Addendum 128 – UN Regulation No. 129

Amendment 12

Uniform provisions concerning the approval of Enhanced Child Restraint Systems used on board of motor vehicles (ECRS)

Figure 3
Minimum distance for lateral impact

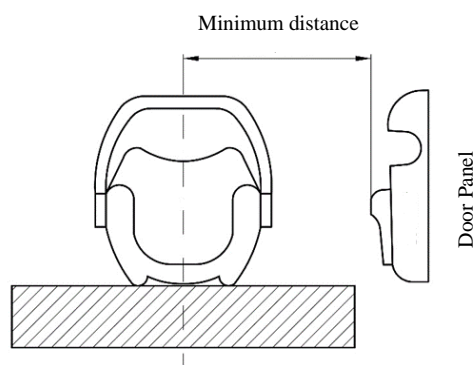
Paragraph 7.1.3., amend to read:

For each test, the initial position of the side impact door panel relative to the bench shall be adjusted according to the minimum distance between the vehicle's door panel and the centre of the seating position as shown in Figure 3.
